# DRB SET "FINAL SUBMITTAL"

DRB 22-0826

## 1211 RESIDENCE

1211 Stillwater Dr,  
Miami Beach, FL 33141

# Design Review Comments

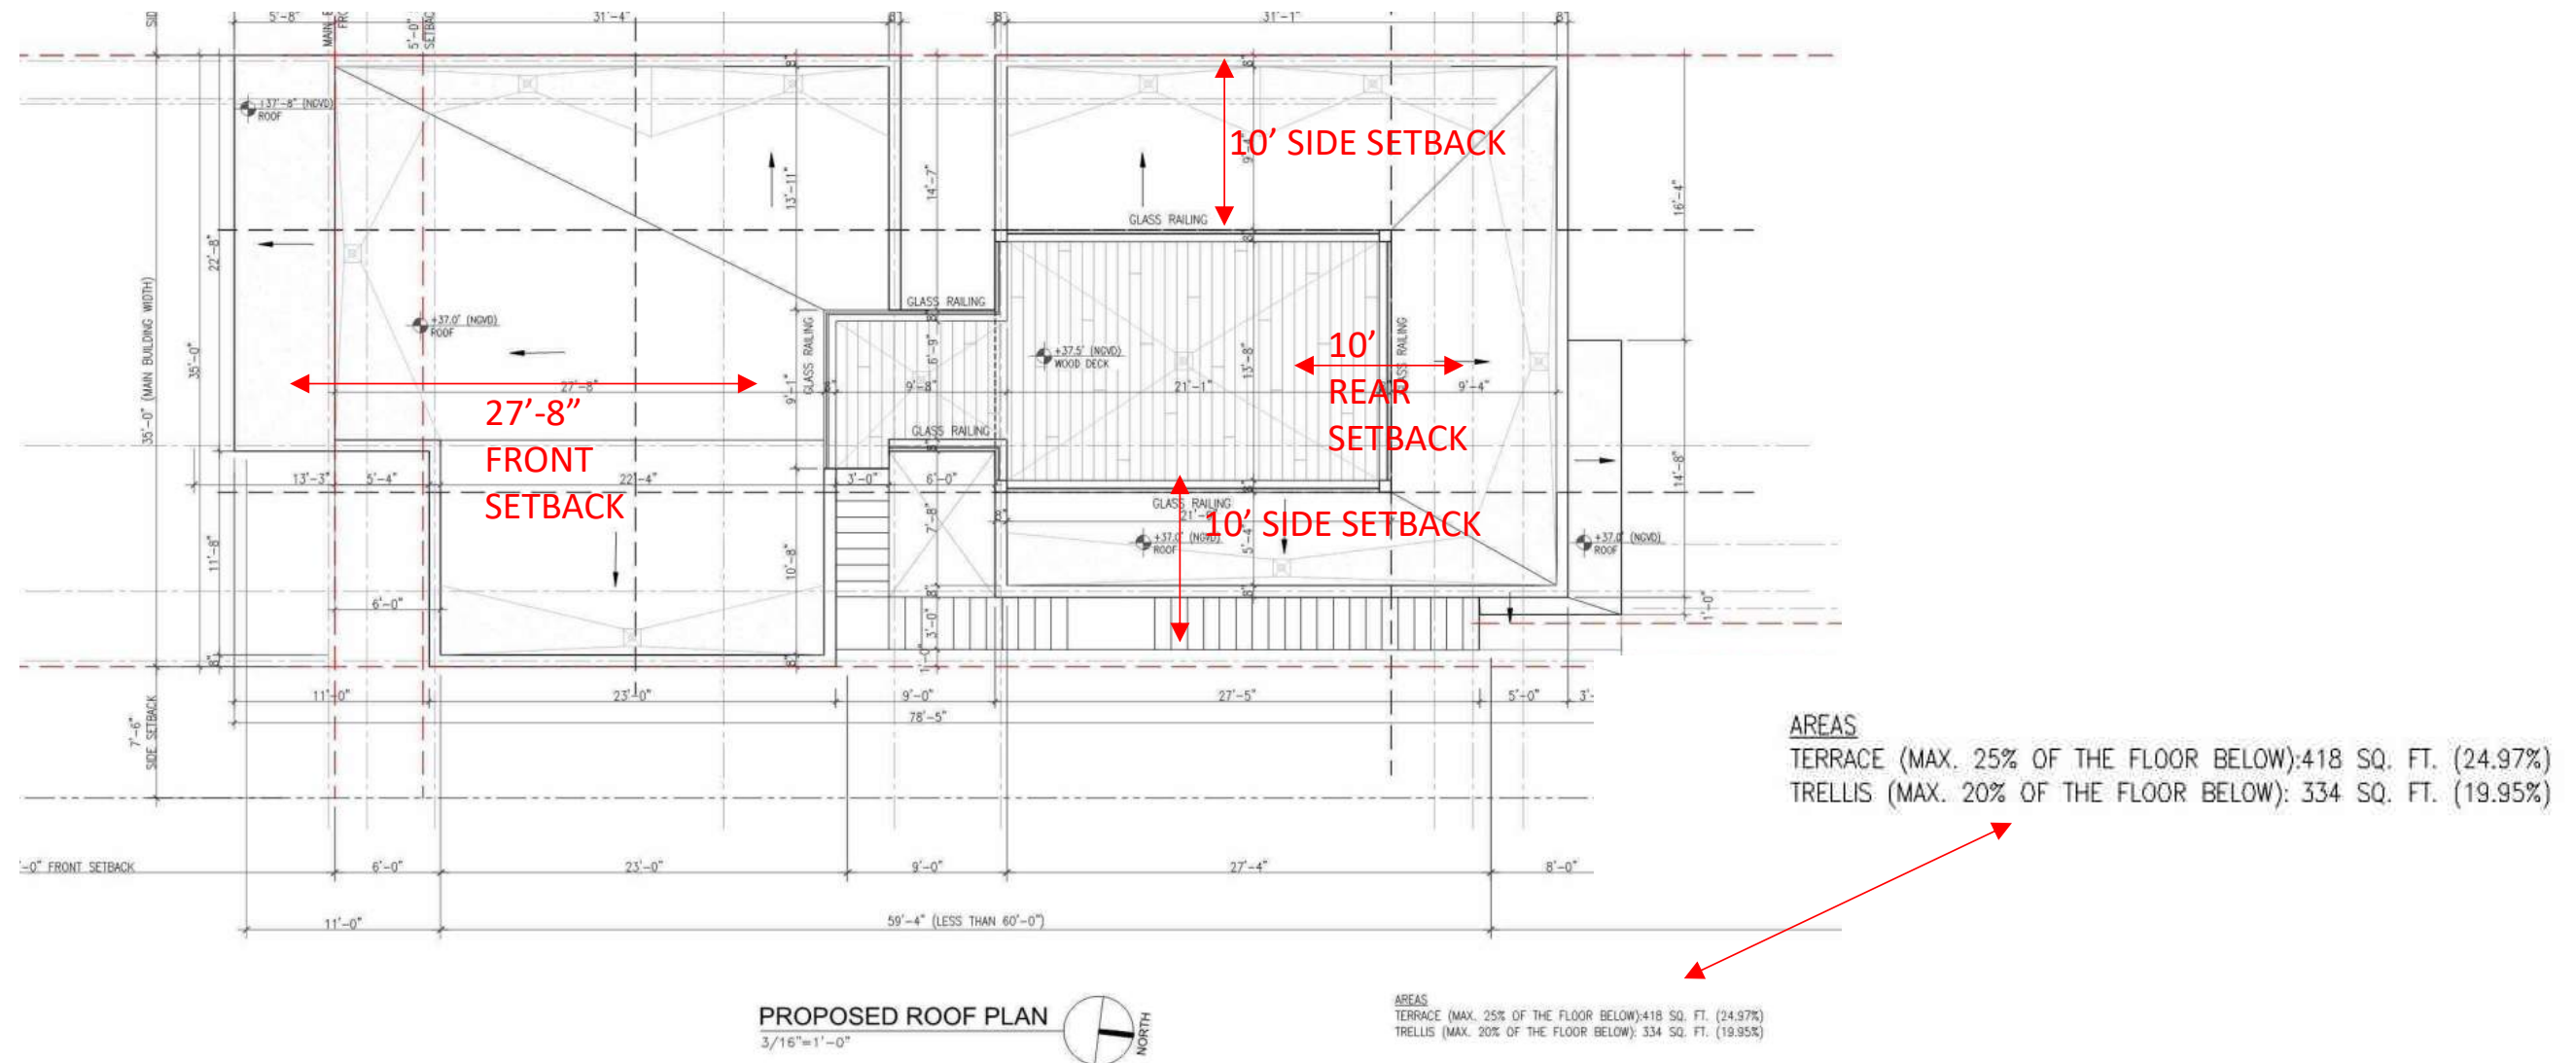
I.D.1.a: Additional landscape in the understory area, [WILL WORK WITH STAFF]

I.D.1.b: Roof Deck setbacks [WE COMPLY, 10' SETBACKS FROM BUILDING EDGE]

I.D.1.c: Trellis Size: On Sheet A-10 listing terrace and trellis size of 334 SF (19.95% of floor below), less than 20%, [WE COMPLY]
